REMARKS/ARGUMENTS

Appl. No. 09/938,040
Amdt. dated Oct. 17, 2003
Reply to Office action of Aug. 6, 2003

FIG. 1 – Prior Art

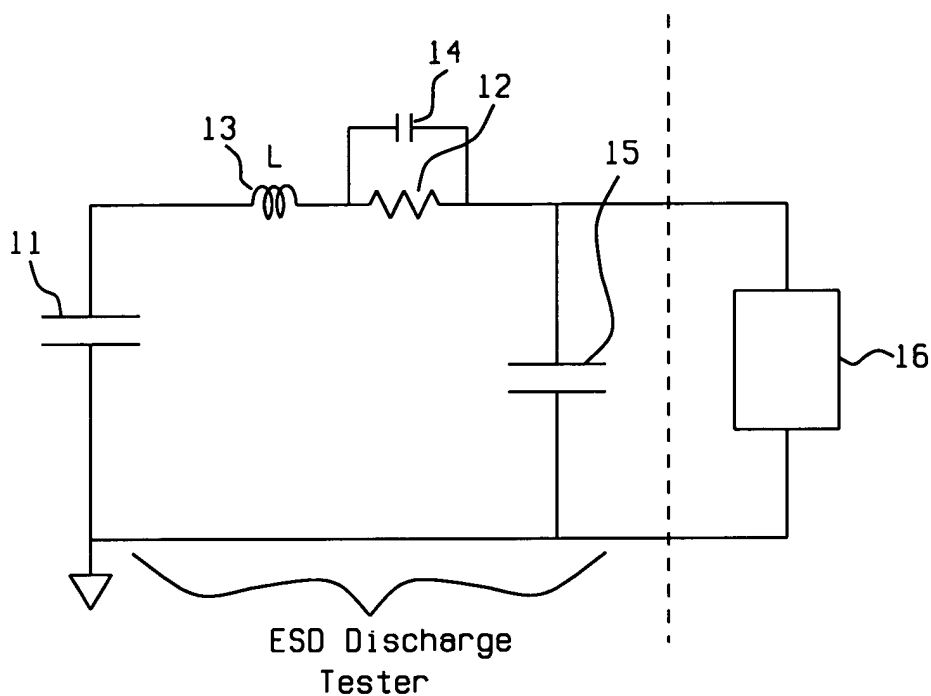
Figures 1 and 2 were amended.

In amended Figures 1 and 2, the previously omitted legend --Prior Art-- has been added.
